# CENTRAL FLORIDA EXPRESSWAY AUTHORITY

SUBJECT: Evaluation of SR 417 & SR 528 Rail Project Cost Estimates

**Evaluation of Project Cost Estimates for  
SR 417, SR 528 Modified Florida High Speed Rail (FHSR) and SR 528 Refined Modified FHSR Alignments  
of Proposed InterCity Rail from Orlando International Airport to Walt Disney World**

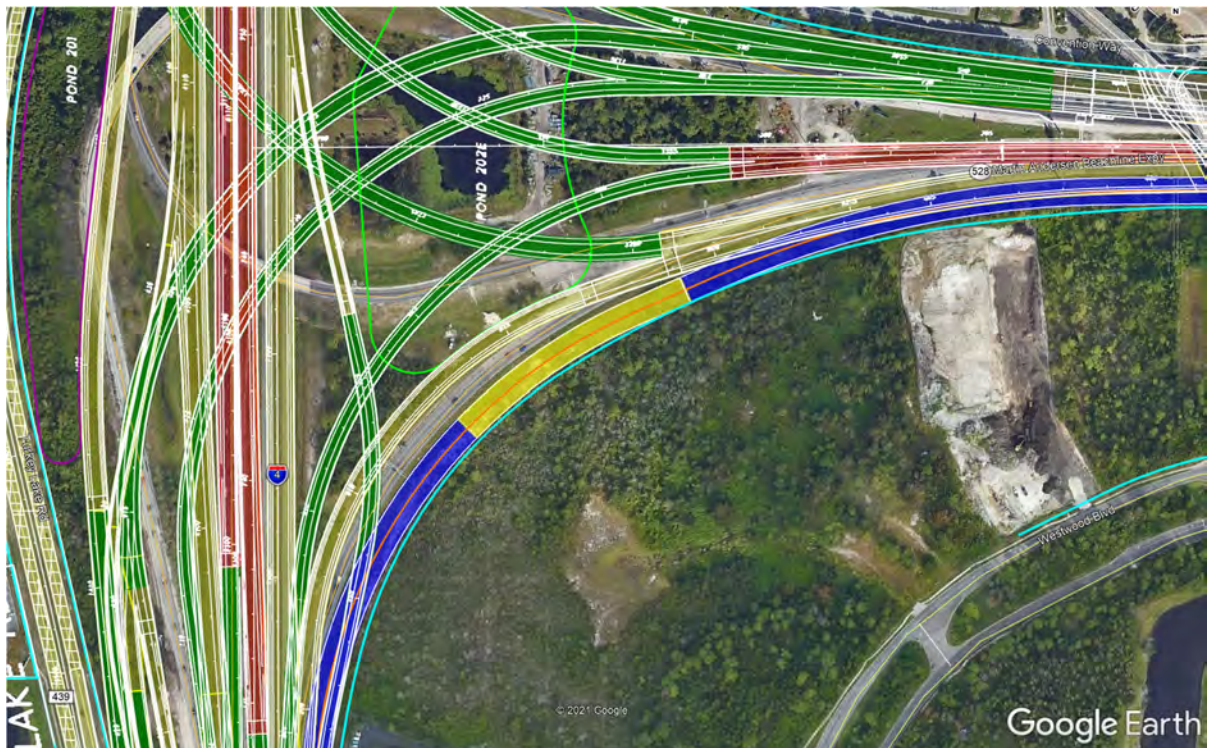
- Q. Upon review of the I-4 BTU plans and comparing that to your KMZ, do you have an exhibit to show how you can fit the proposed rail alignment will fit within the R/W at the southwest quadrant of the SR 528/I-4 interchange with the I-4 BTU improvements?

- A. The kmz files of the I-4 BtU design in this section along with the kmz file of the TVR / SR 528 alignment were provided to Keith Jackson (Dewberry). Below is a screenshot of this section.

Exhibit C – Increased 417 Route Length

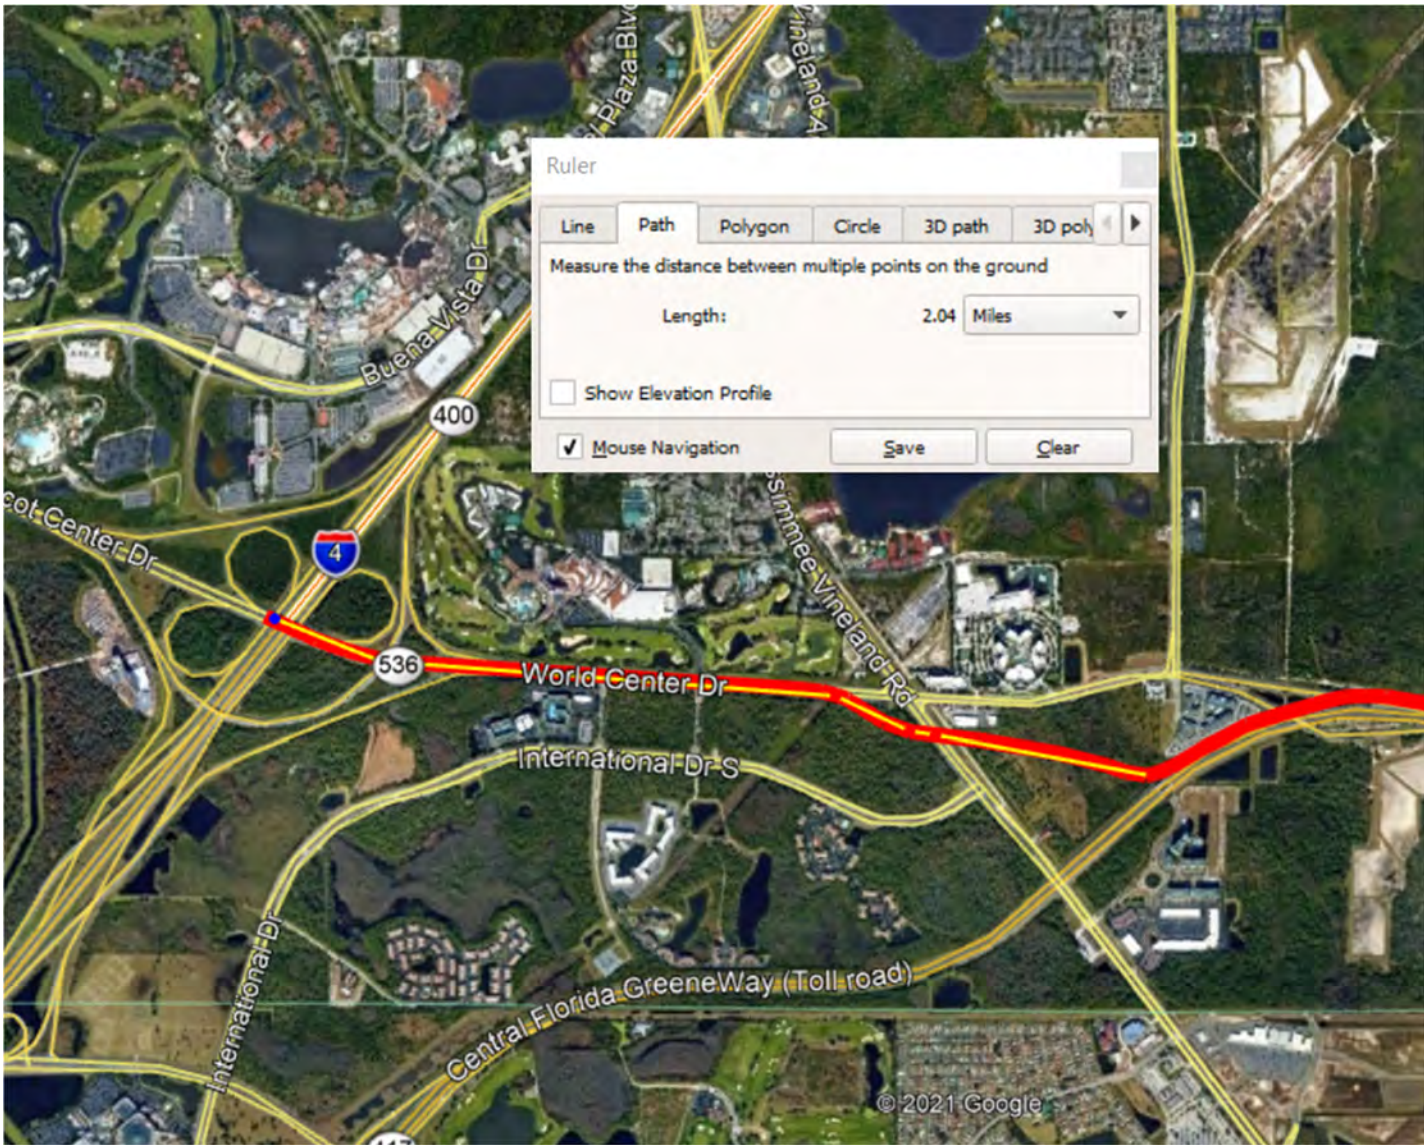
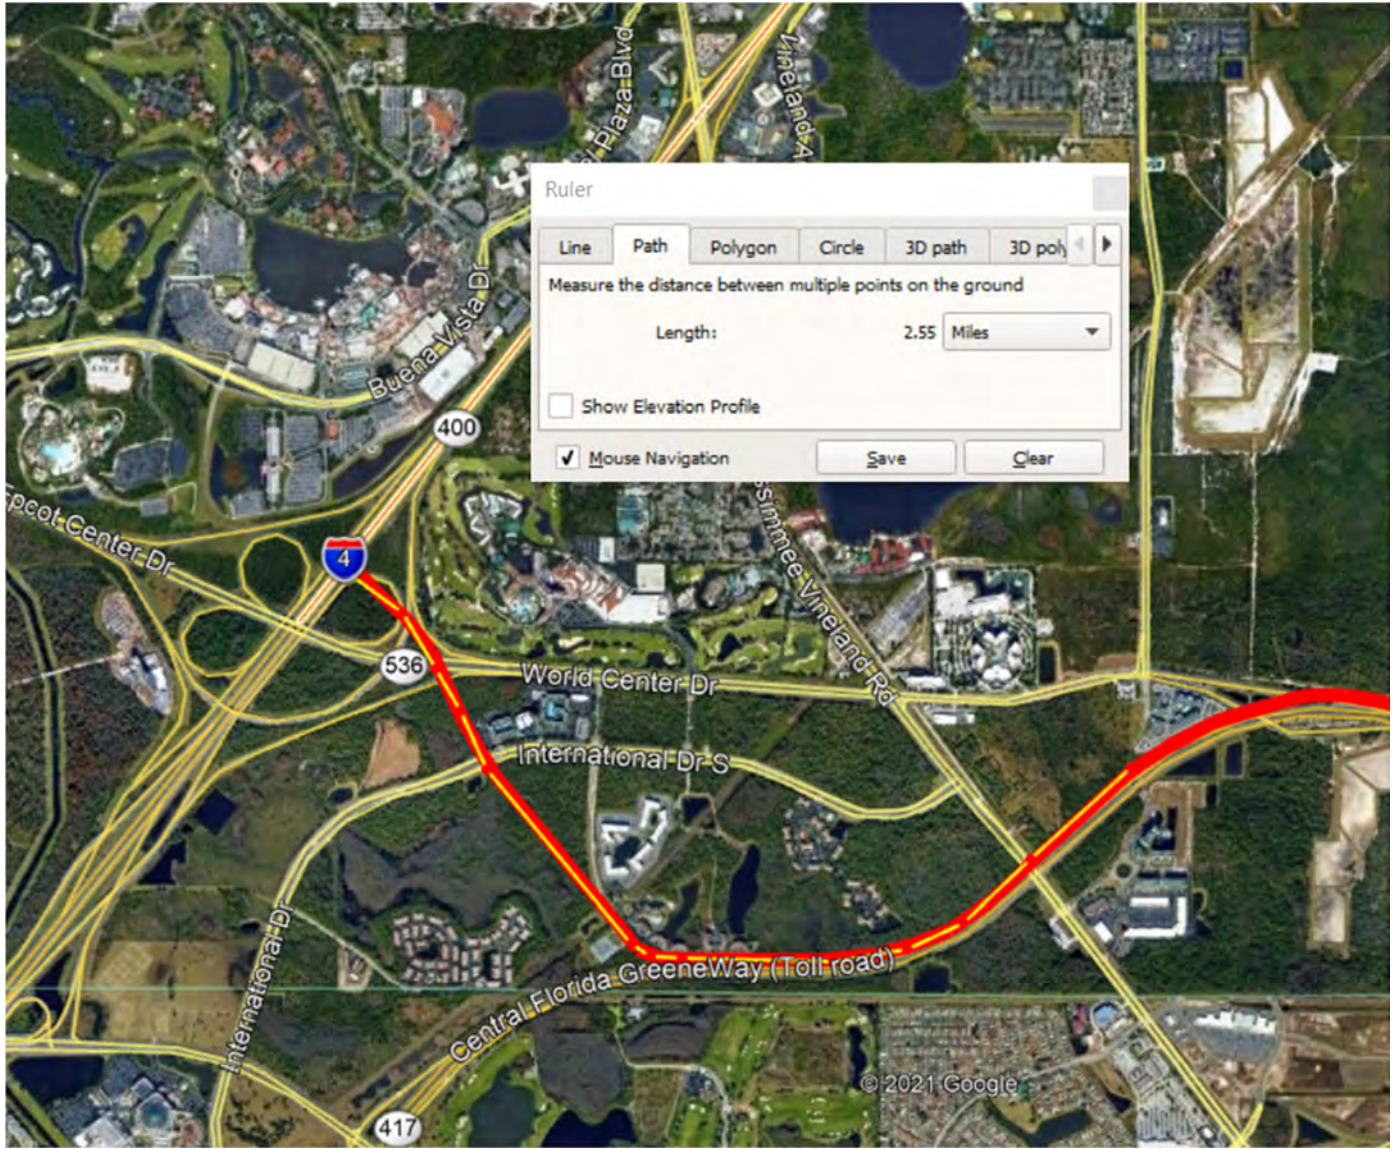
The new alignment from 417 to Disney appears to add .5 miles to the overall 417 route distance. Using Brightline’s per mile route cost for this section adds a minimum of \$40 million.

Exhibit D – MSE Wall Along SR 417 Route

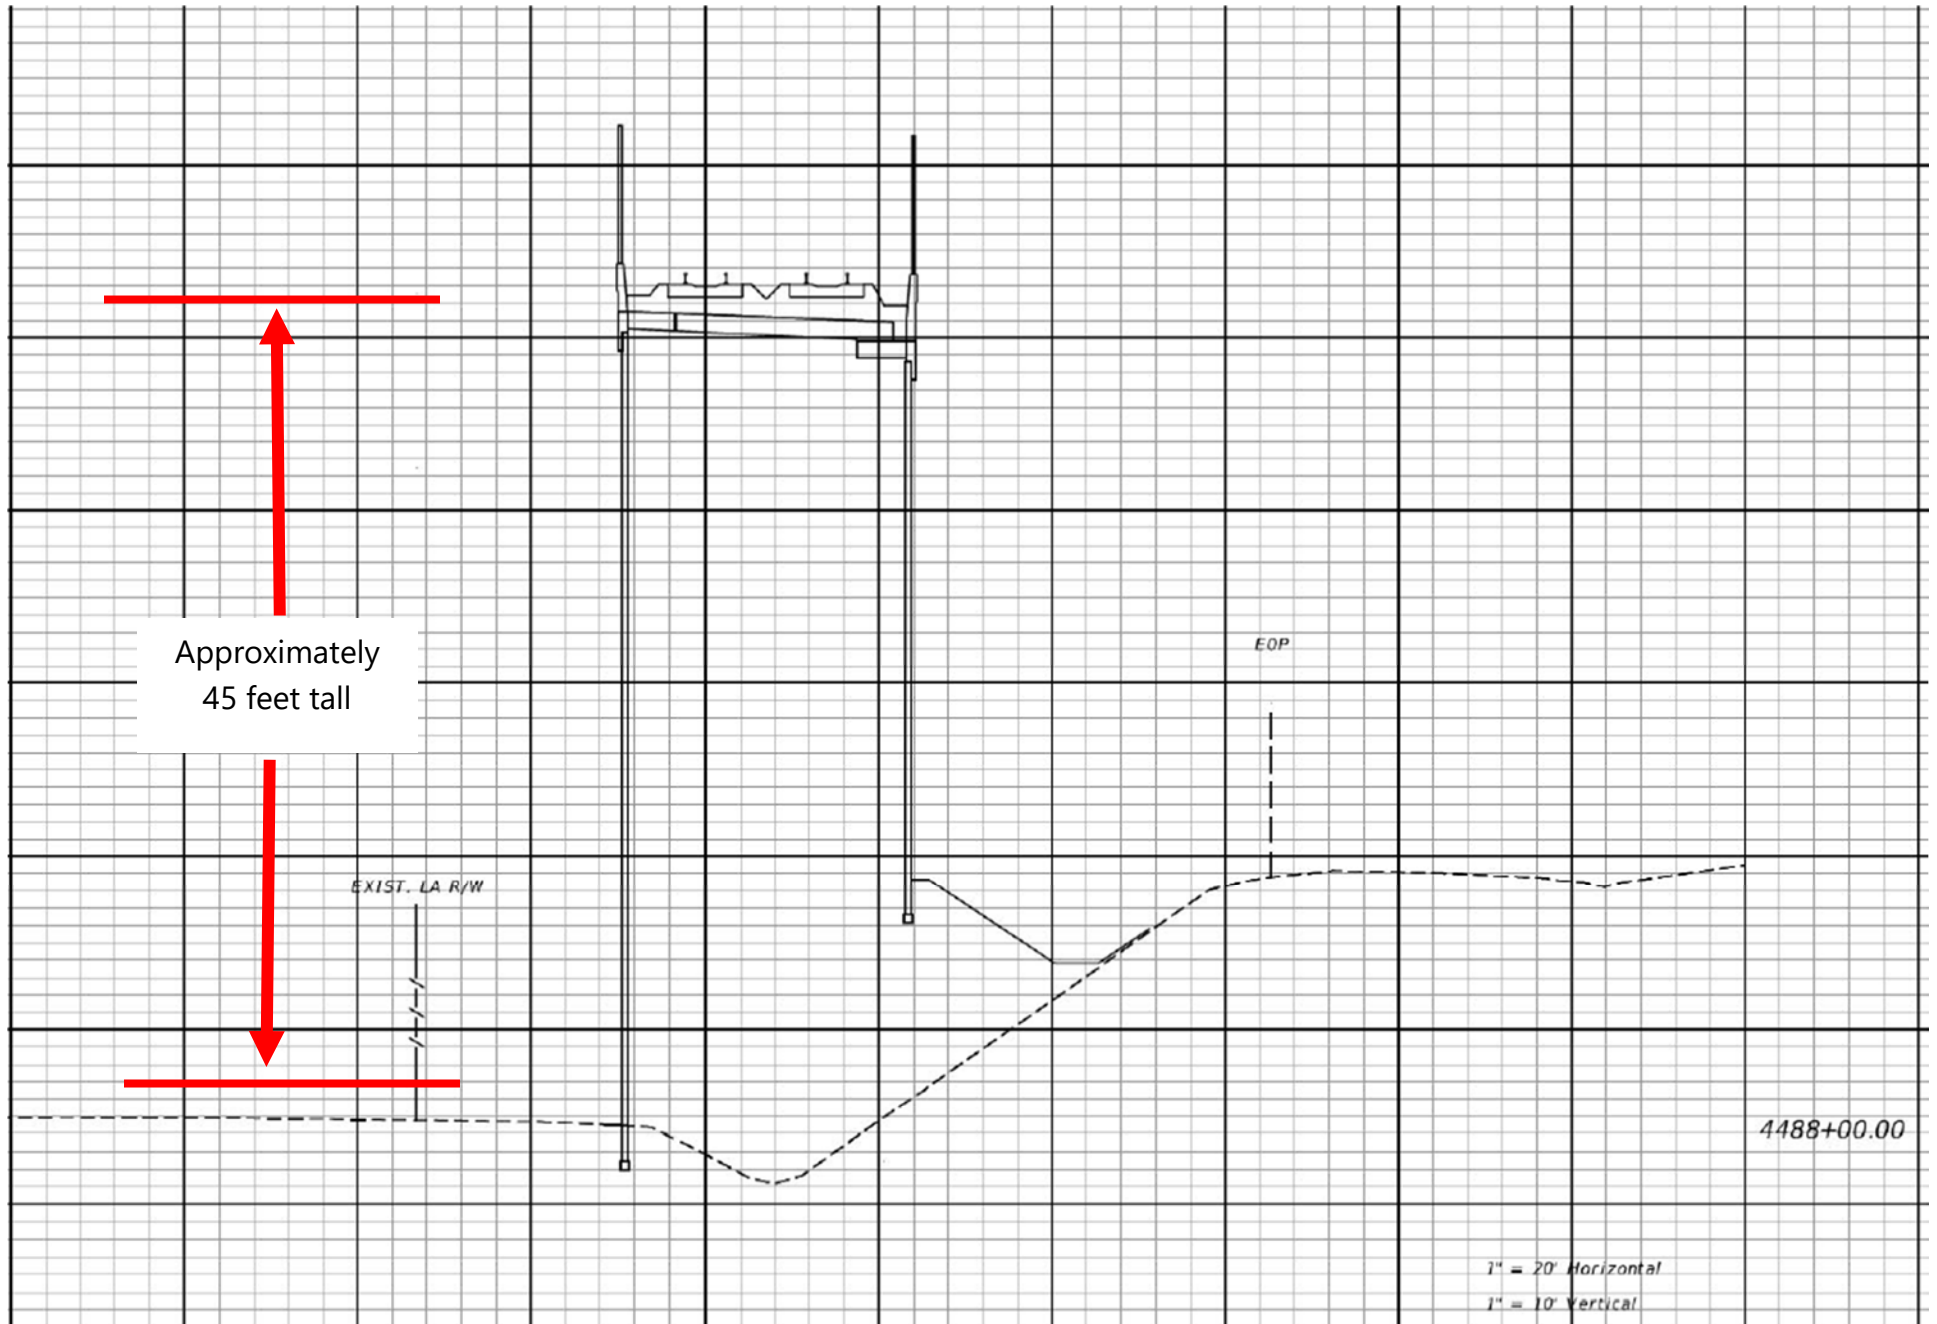
The unit costs of the walls for the 417 route and the Convention Center route cannot be the same. The costs of the walls on the 417 will be greater due to the increased heights of walls shown in the plan, restrictive access along the property line, and constructability issues associated with construction along 417, etc. Over the length of the alignment, the delta in unit cost combined with the significant amount of wall could create a significant increase in the 417 route estimate. Actual unit costs associated with these specific walls are required in order to make a reasonable comparison.
